MAINE TURNPIKE AUTHORITY

ADDENDUM NO. 3

CONTRACT 2018.20

YORK TOLL PLAZA
MILE 8.8

ESTIMATED QUANTITIES 1

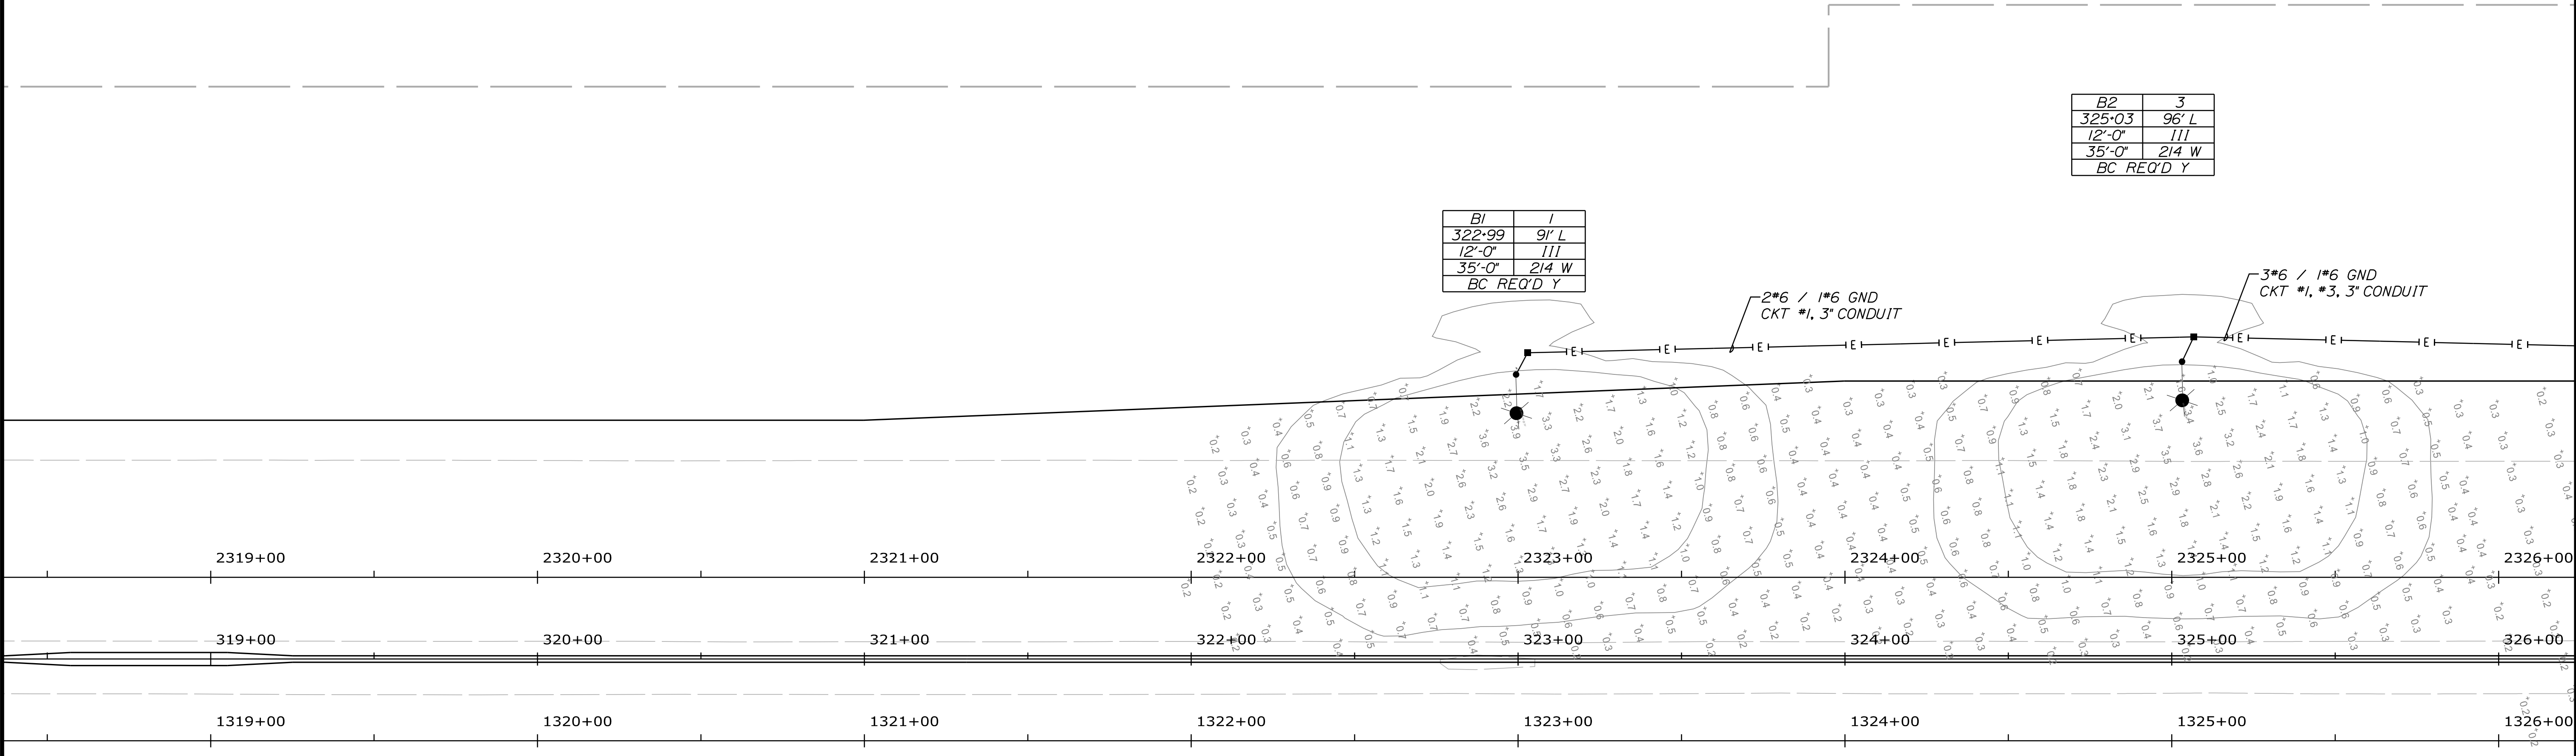
Plan Sheet 3 of 489, "Estimated Quantities 1" is deleted and replaced in its entirety with attached revised sheet 3 (Revised 10/4/18). The following was deleted:

634.2042	LED Luminaires	Each
634.210	Conventional Light Standard	Each

The following was added:

203.211	Presplitting Rock	LF
634.231	Conventional Light Standard with LED Fixture	Each
634.232	Sign Light	Each

LIGHTING PLAN 1

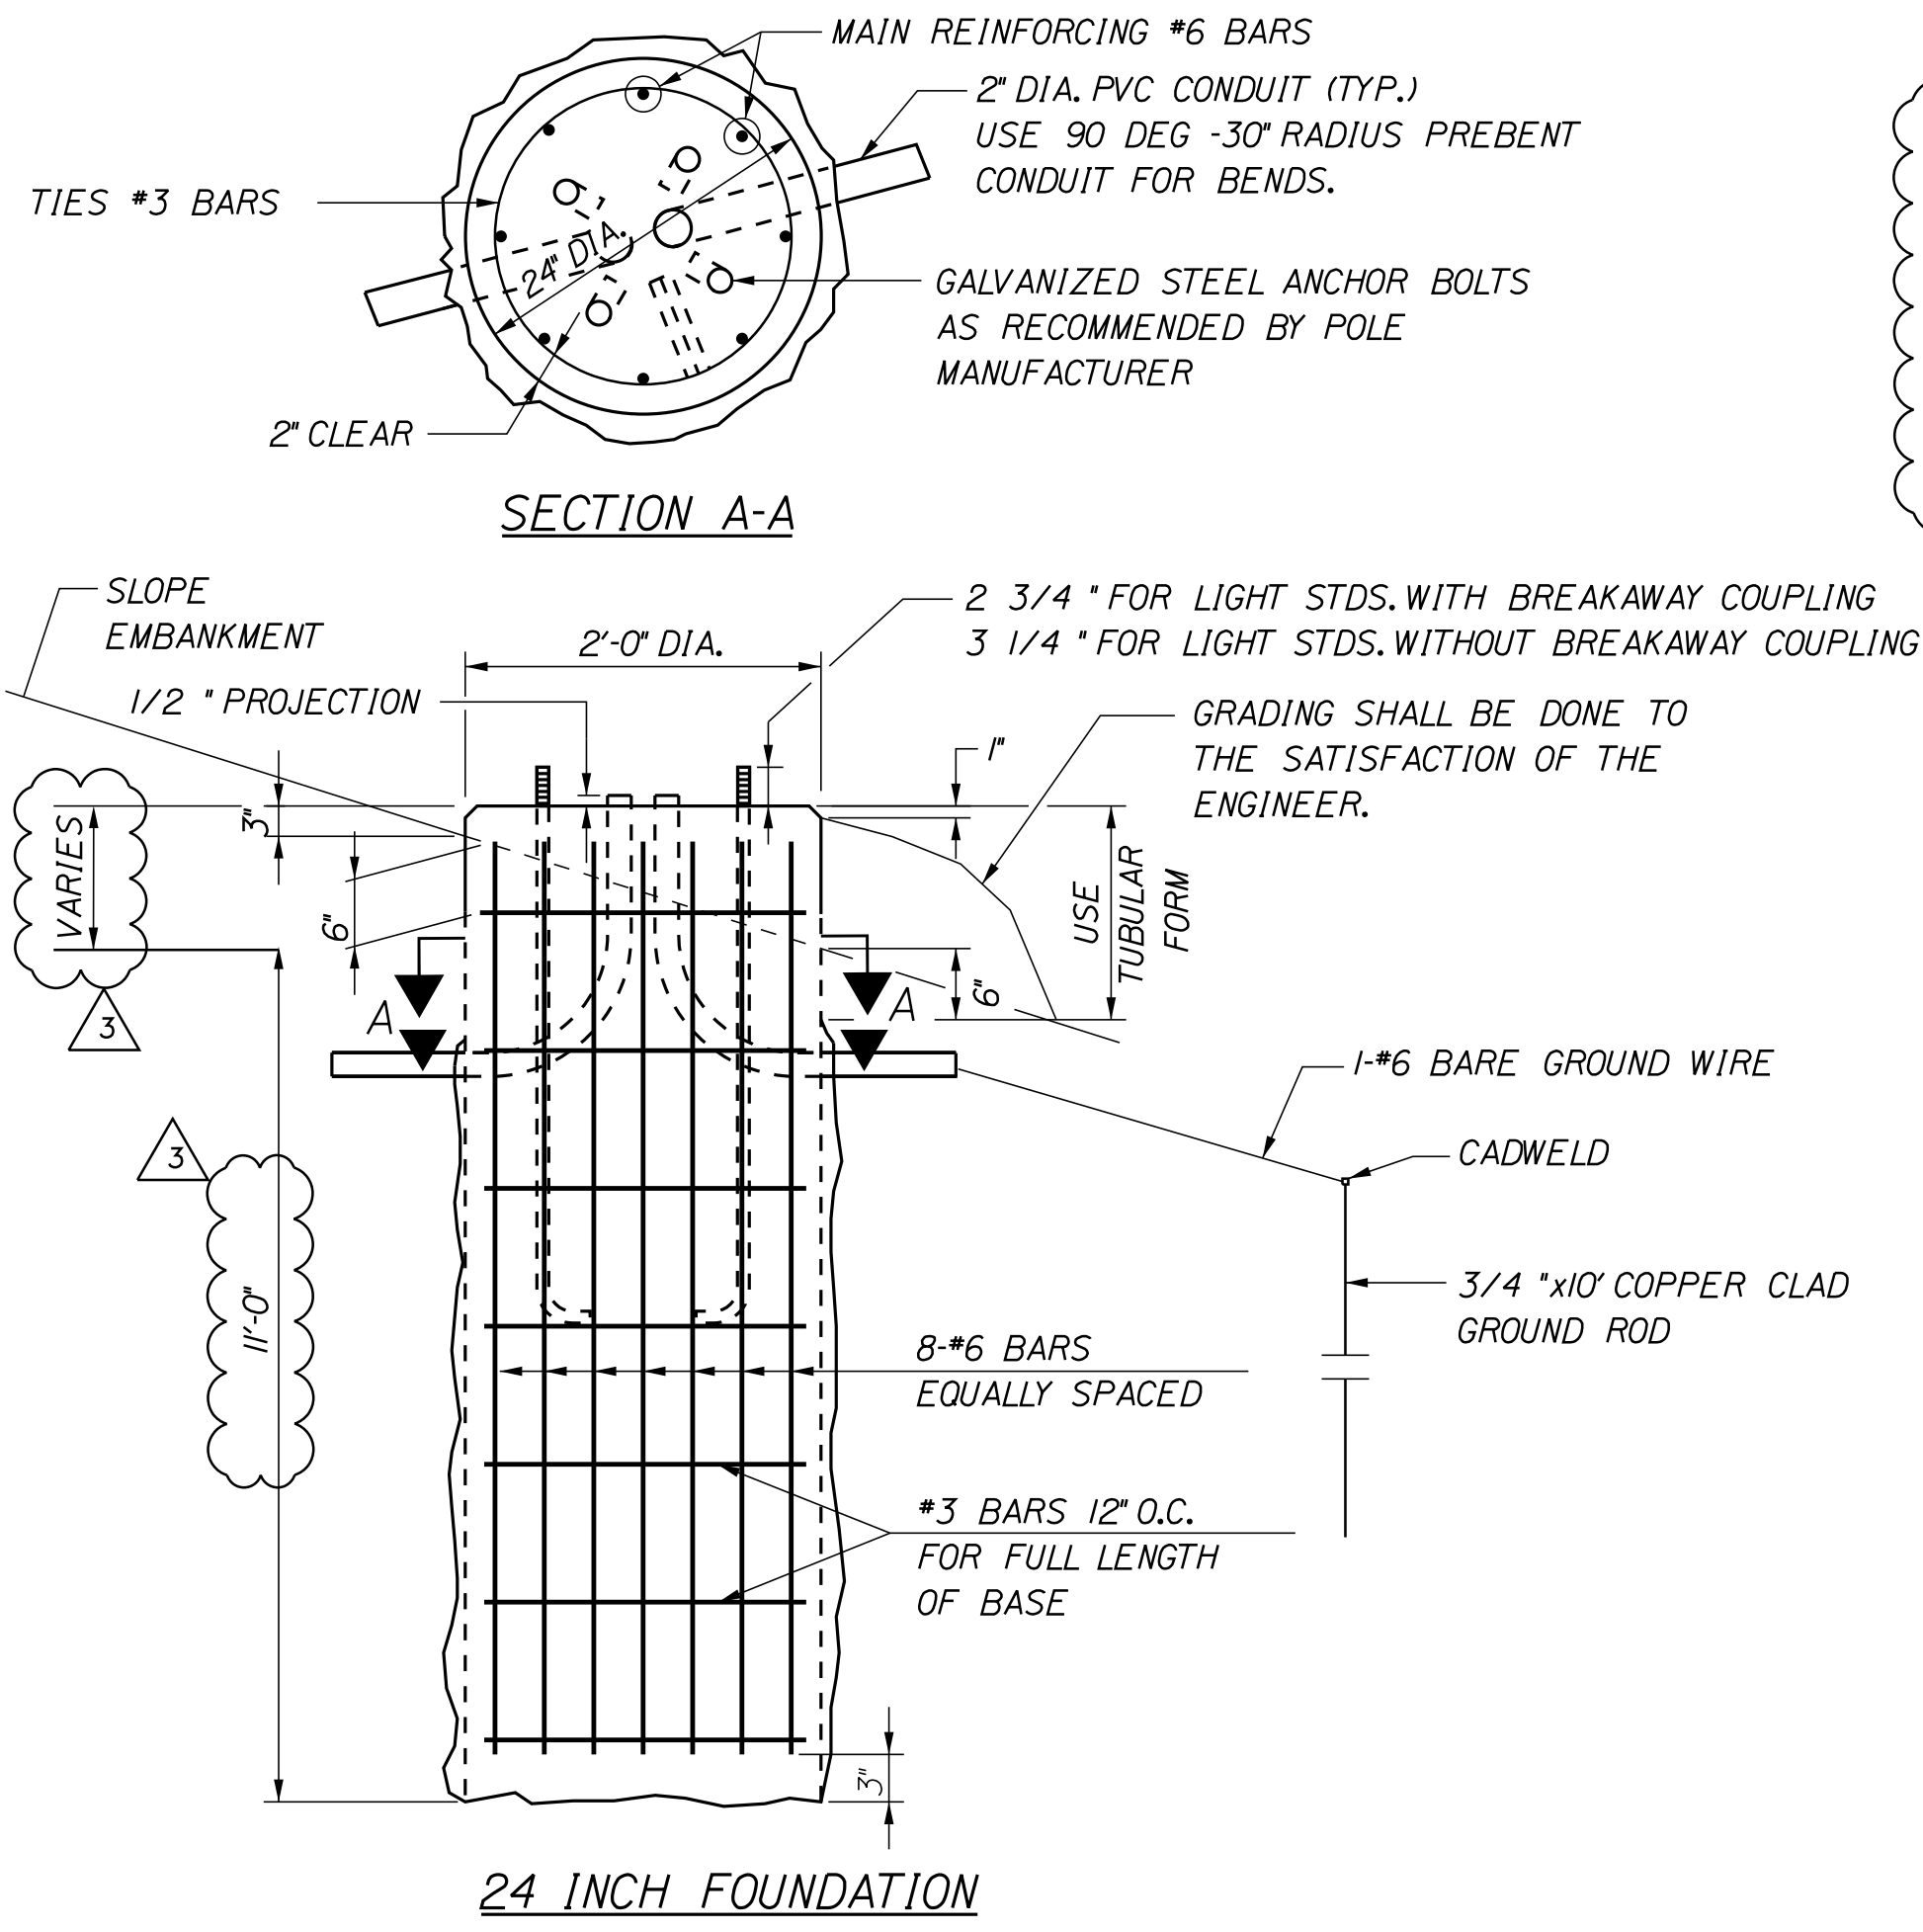
Plan Sheet 152 of 489, "Lighting Plan 1" is deleted and replaced in its entirety with attached revised sheet 152 (Revised 10/4/18). Placement of Light Standard detail was revised.

PLACEMENT OF LIGHT STANDARD
NO SCALE

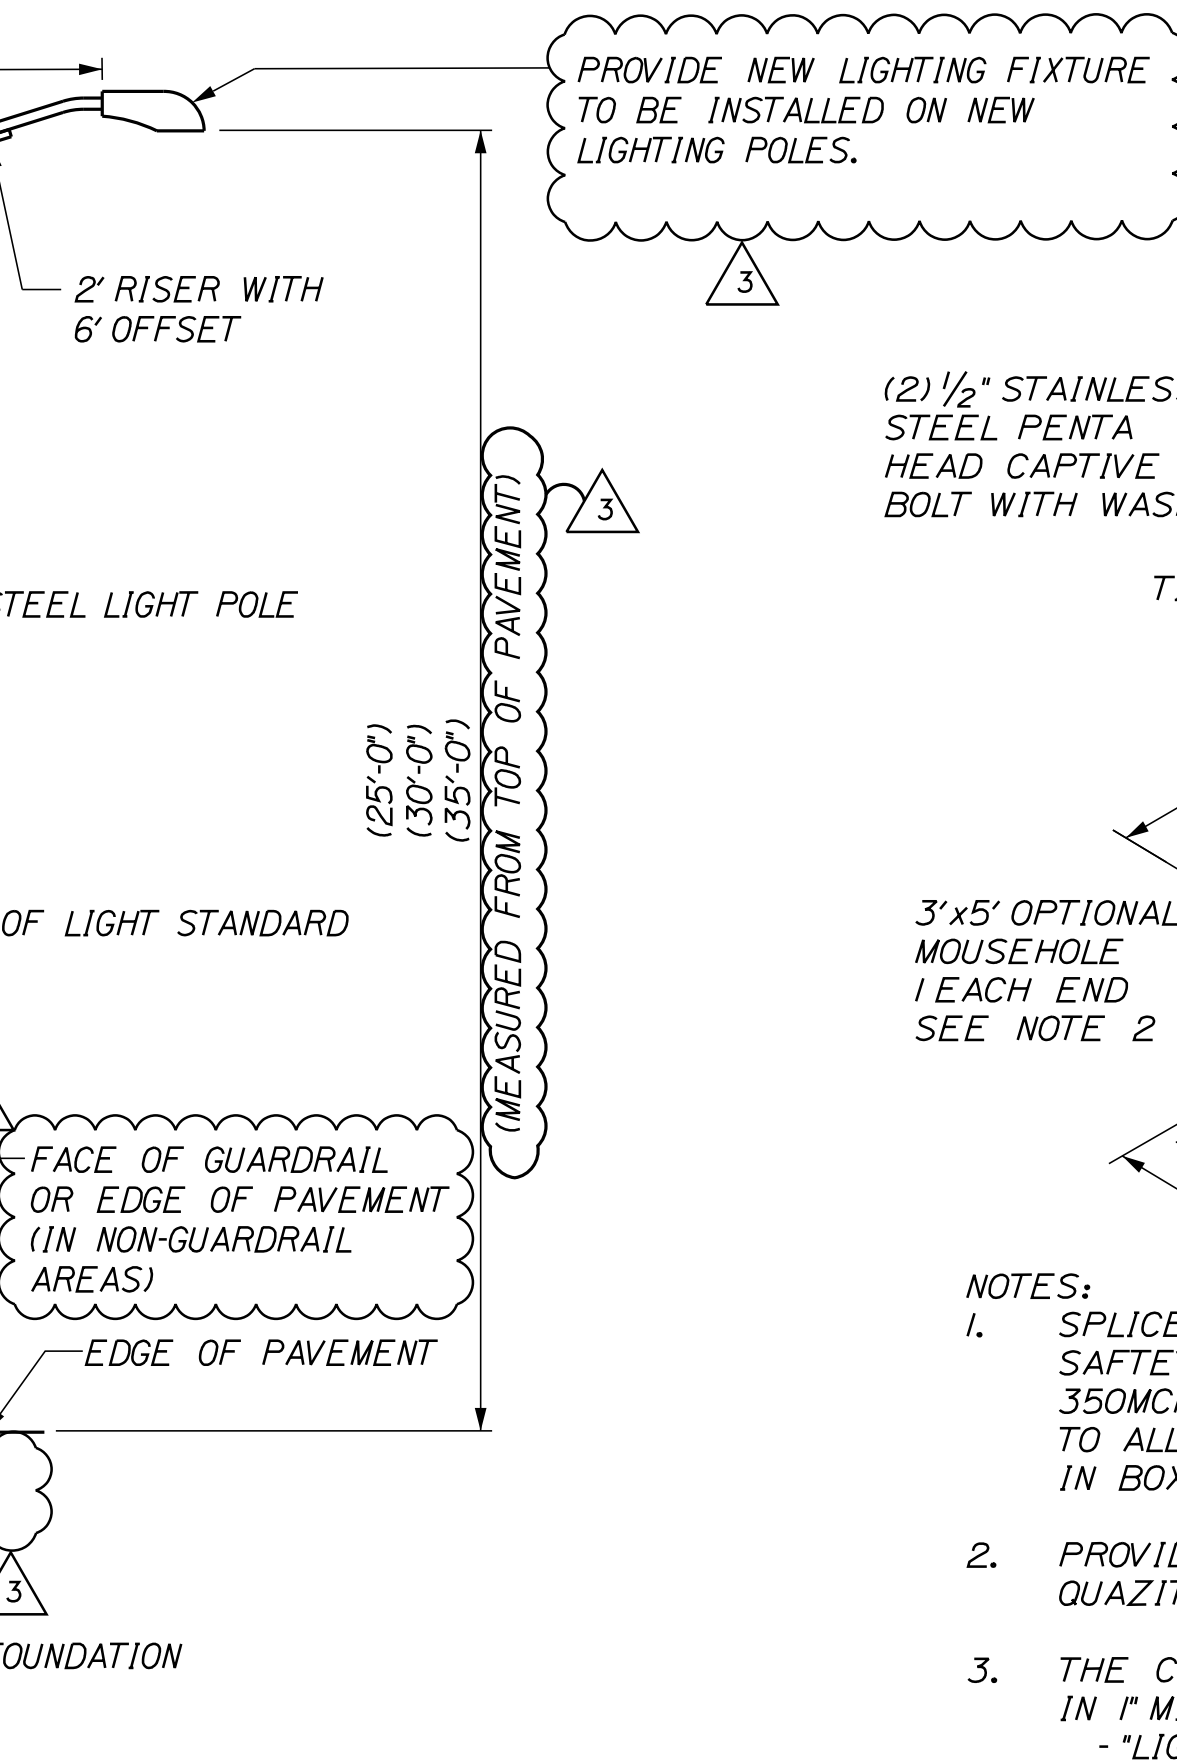
Plan Sheet 165 of 489, "Lighting Details" is deleted and replaced in its entirety with attached revised sheet 165 (Revised 10/4/18). Placement of Light Standard detail and 24 Inch Foundation detail was revised. Deleted Removal of Concrete Foundation Detail and Placement of Light Standard chart.
